**PERSIMMON HOMES THAMES VALLEY
LAND NORTH OF TODDINGTON LANE,
LITTLEHAMPTON**

**DRAINAGE STRATEGY, WEST OF
WETLANDS
(DISCHARGE OF CONDITION 10)**

Project Code:	A/PHDRAIN.10
Prepared by:	SF
Approved by:	AB
Issue Date:	24th January 2019
Status:	1st Issue

From: Laura Gibbons <Laura.Gibbons@arun.gov.uk>
Sent: 16 January 2019 11:05
To: Sean Foley
Cc: Clark, Robert; Michael Eastham; Edgley, Martin; Adrian Barnley; Steven Lecocq; Fatima Evernden; Tracey Headley-Smith; Alex Wray; Adam Winstone
Subject: RE: Planning Consultation on LU/345/18/DOC

Image below: Shows the locations of the permeable sub-base within the Windes model..

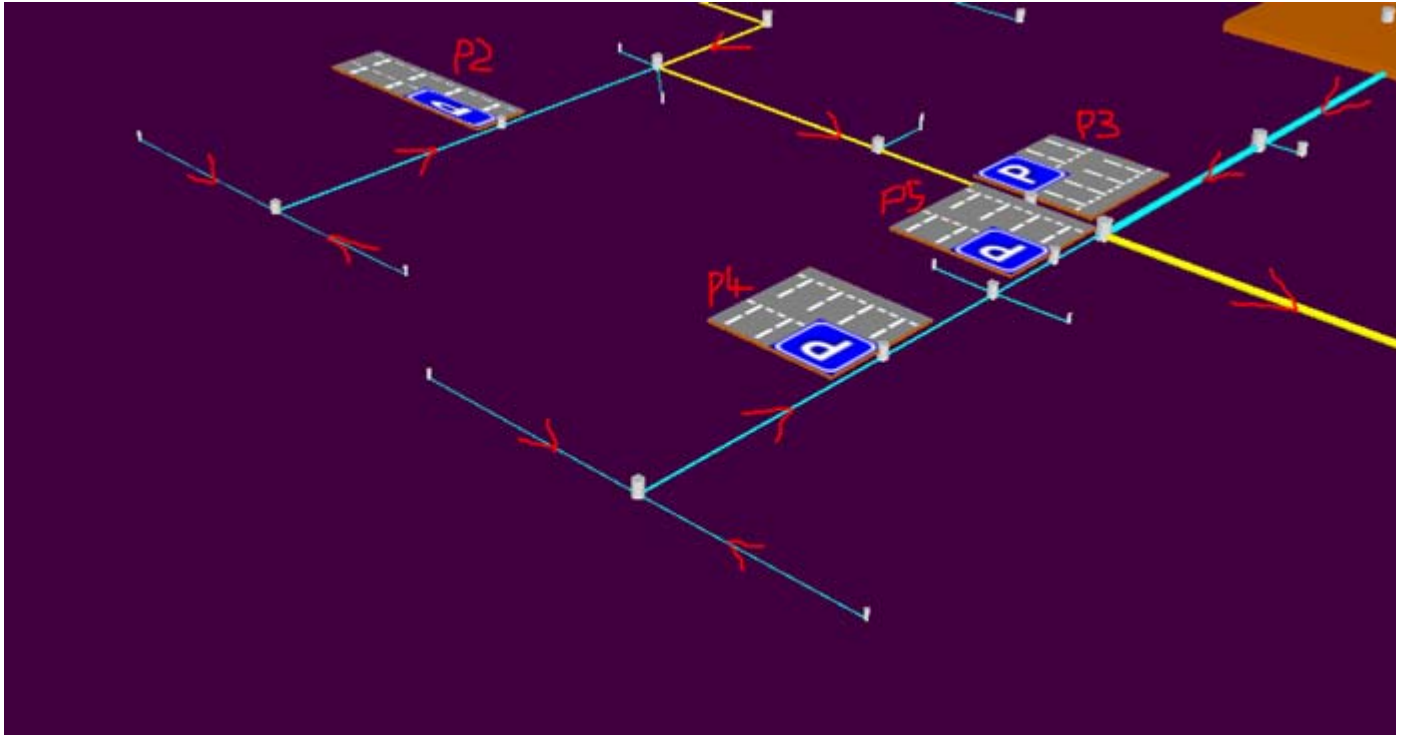
Whilst reading the response below please note we have updated our Windes model so it now includes the permeable sub-base. See image below where we've added new nodes and modelled is as a "porous car park" (function within the programme) where the storage within 30% voids of the granular sub-base is recognised. We have distributed it as evenly as possible across the areas where the granular sub-base is located. The addition improves the results significantly and the total flooding volume for the fully surcharged critical 1in100yr+CC storm is now only 35m3 (spread across 4 different locations) that can safely be contained within the site.

Appendix H
Existing Discharge Rates

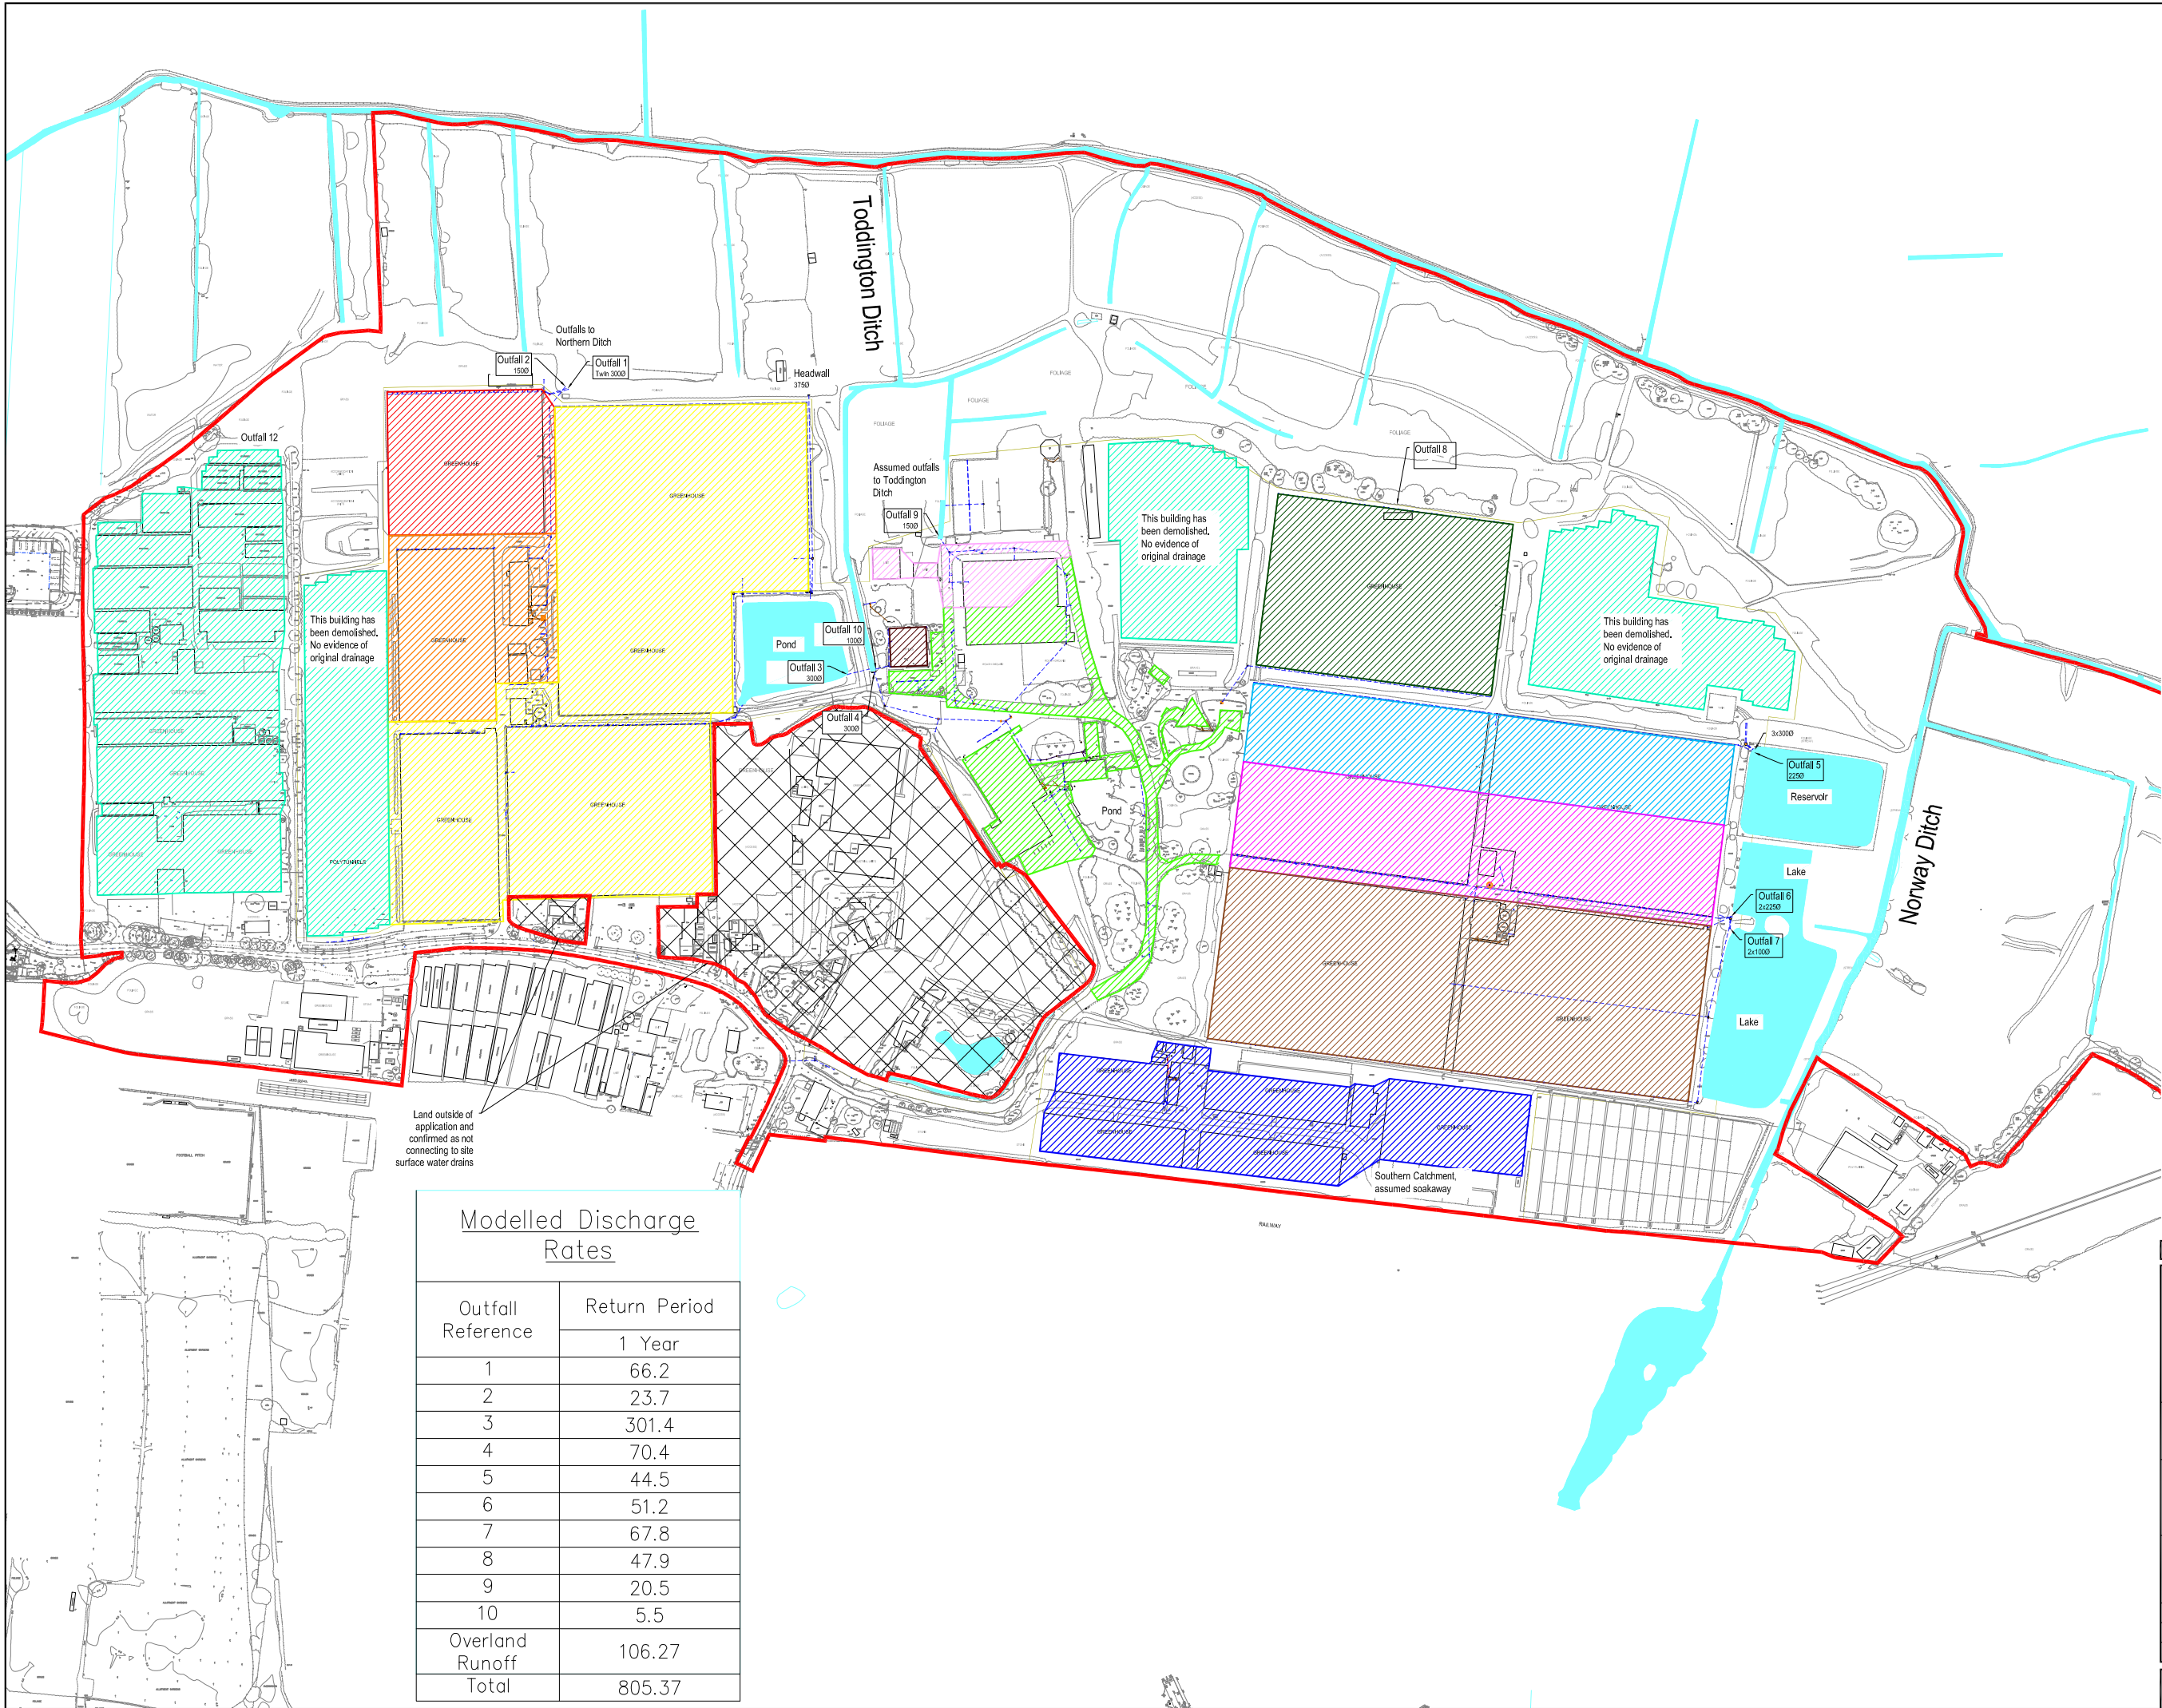
- The area at point 11 (PN 31.000) in the model and plan are inconsistent. Within the model you have 0.215 ha Impermeable area at PN31.000 and 0.043 ha at PN31.001. This is less than the 0.358 ha on plan. The other areas are okay as you have clarified that they are totals.

MBL Response: You are correct. The modelled figure at PN31.000 did not match the plan. The model was okay but the plan was not. This is now updated on the plan as a 60:40 split between PN31.000 & PN18.000. Has been updated on appendix H
